Carlos Leather Fashion Ltd. (10099)

Teknog Para, Chandona Chourasta, Joydebpur, Gazipur

21.AUGUST.2014

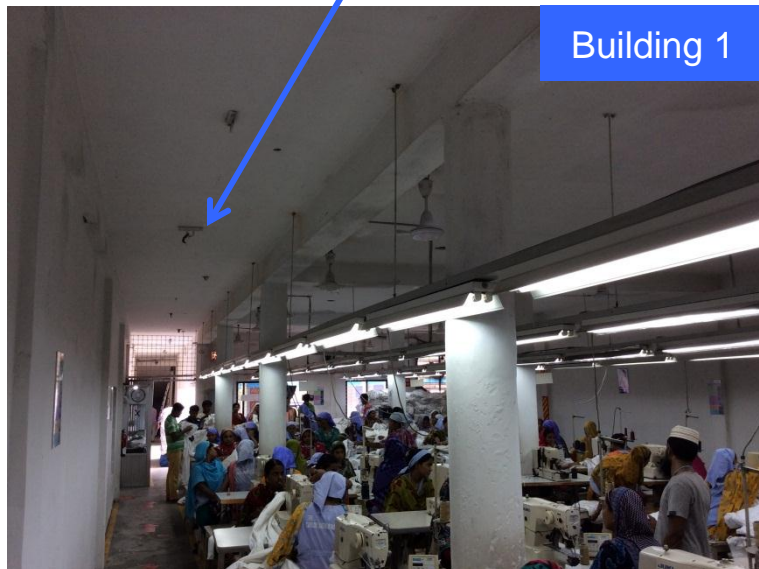
The beams specified in structural drawings shown on the left were not found.

The structural drawings need to be revised.

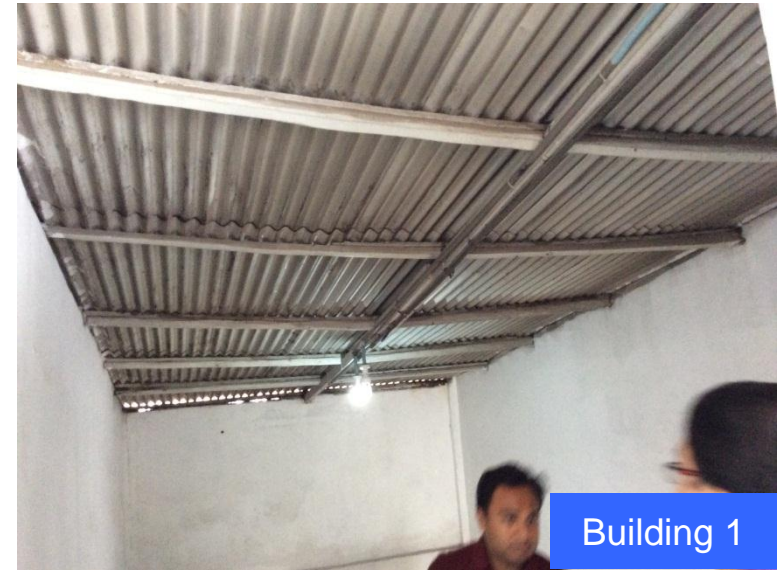
There are also no structural drawings provided for the extension of Building 1 and Shed 1.

Building 1

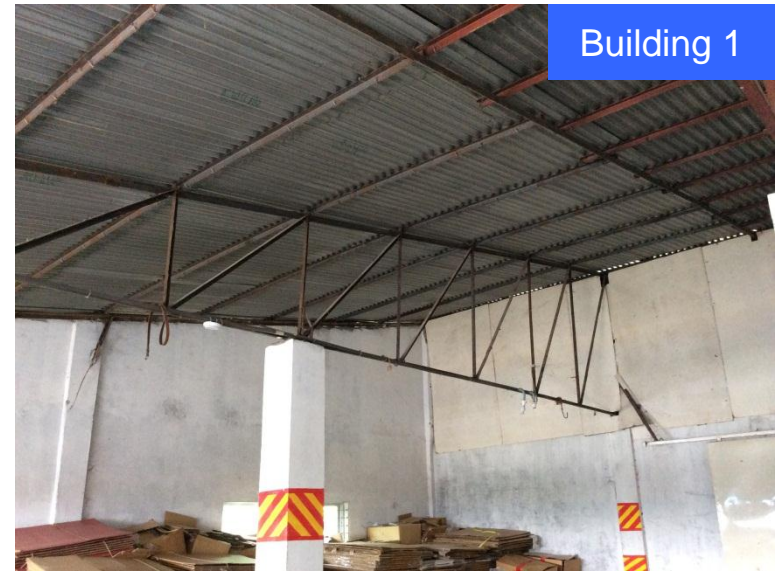
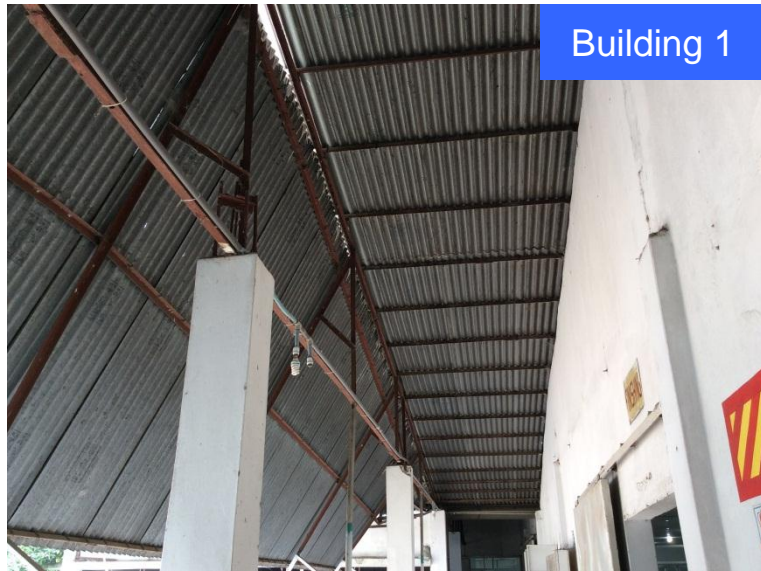
Concerns on the lightweight roof at Building 1. Stability and capacity must be checked especially the connections. Stability under wind uplift needs to be checked in particular.

Concerns on stability and capacity of the steel stair on Building 1.

Concerns on the roof slab supporting water tanks. A capacity check of this slab and all related elements need to be carried out.

These should be investigated and/or strengthened.
